8 REPORTS DIRECT TO COUNCIL**8.3 PELICAN WATERS SOUTHERN LAKES CHANGES TO INFRASTRUCTURE AGREEMENT**

File No: 2009/510022.05

The purpose of this report is to seek Council's determination of a request to vary an Infrastructure Agreement for the Pelican Waters Southern Lakes Preliminary Approval.

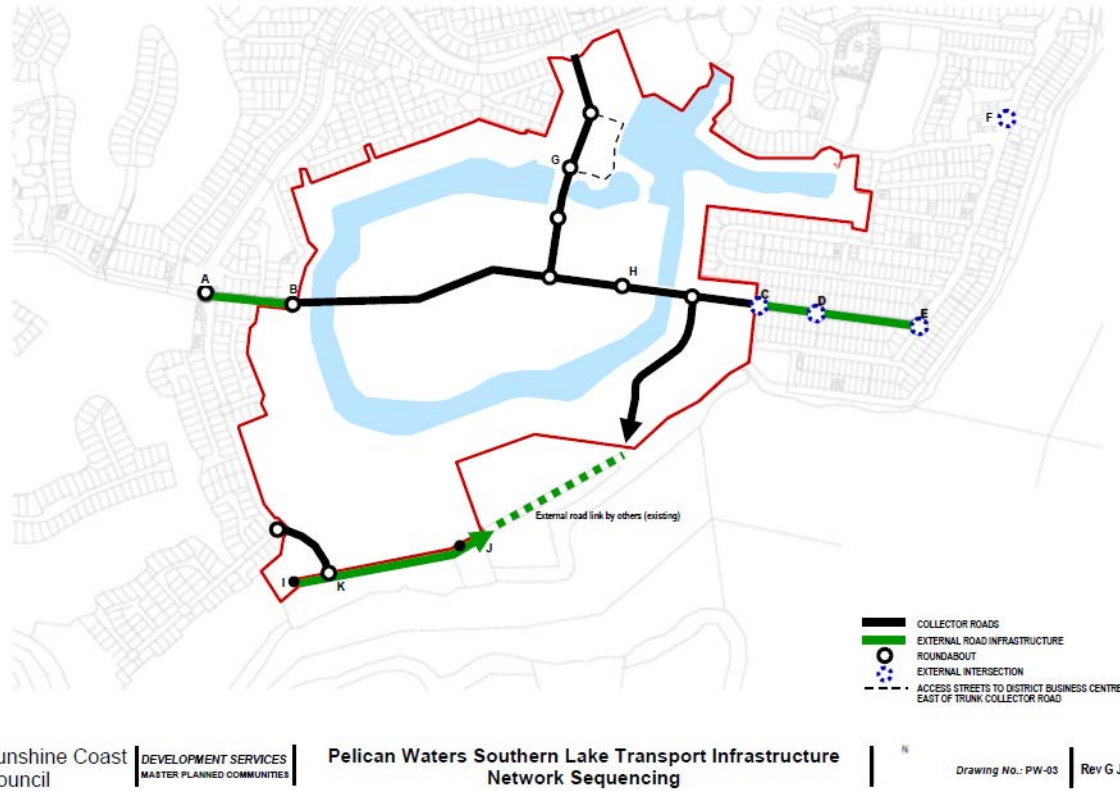
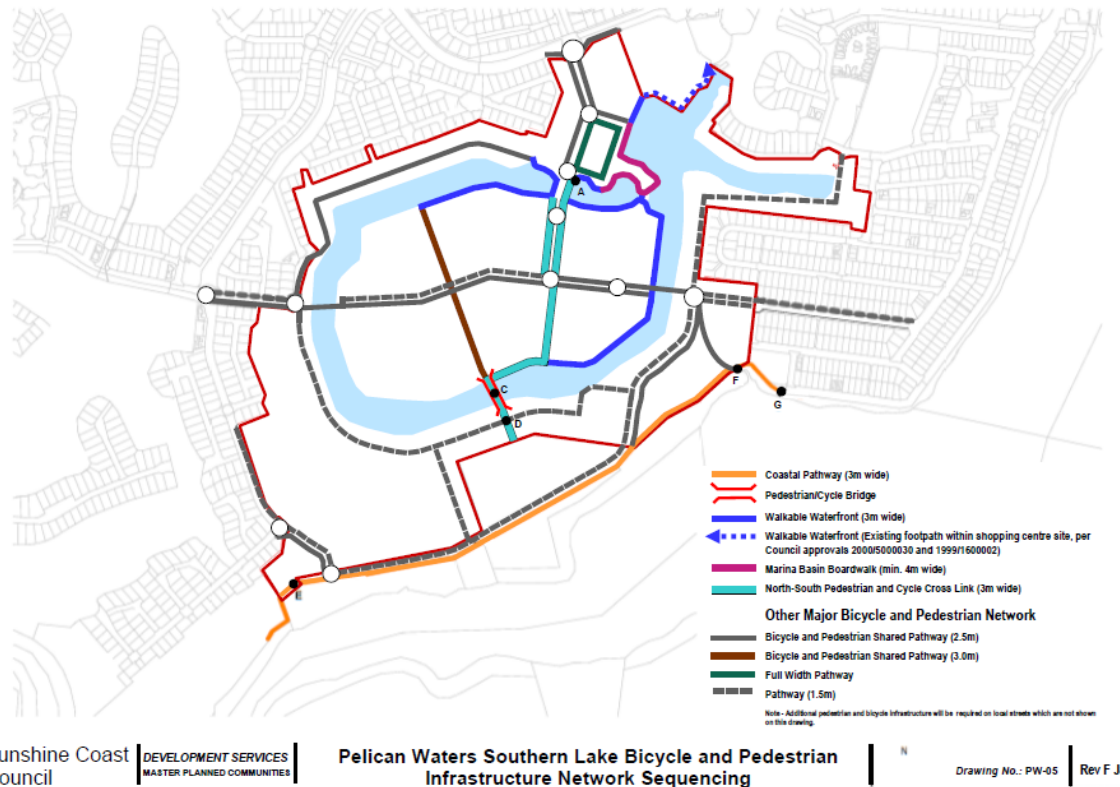
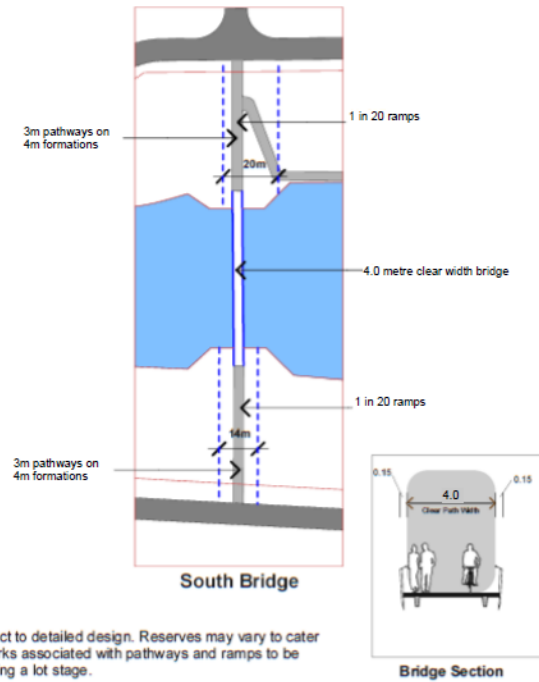
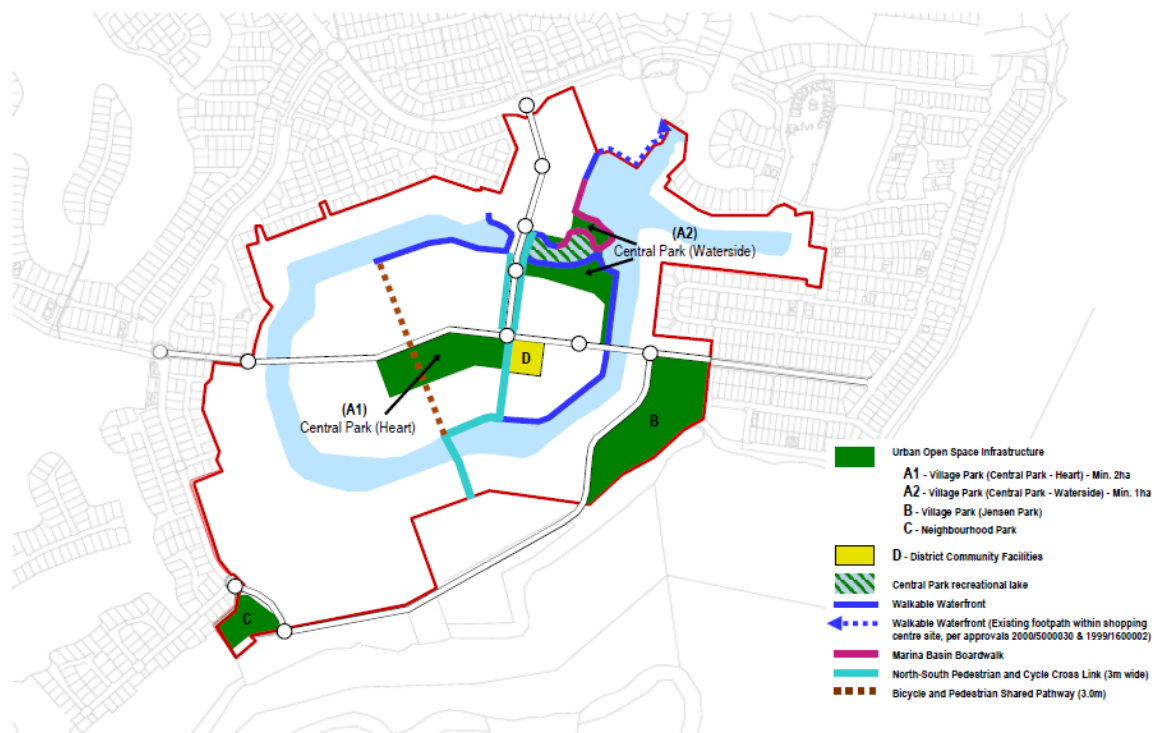
The draft Deed of Variation includes updated drawings 3, 5, 6 & 7 to supersede the drawings in the current IA which generally reflect the changes discussed above. Below are the proposed new drawings:

upgrades. With the exception of the changes to the Central Park on Drawing 7, there is no objection to Drawings 3, 5 and 6 superseding the corresponding drawings in the current Infrastructure Agreement.

Should Council elect to approve the proposed amended open space configuration (as discussed above) Proposed Drawing 7 (Figure 22) should also be included in the Deed of Variation as proposed by the applicant.
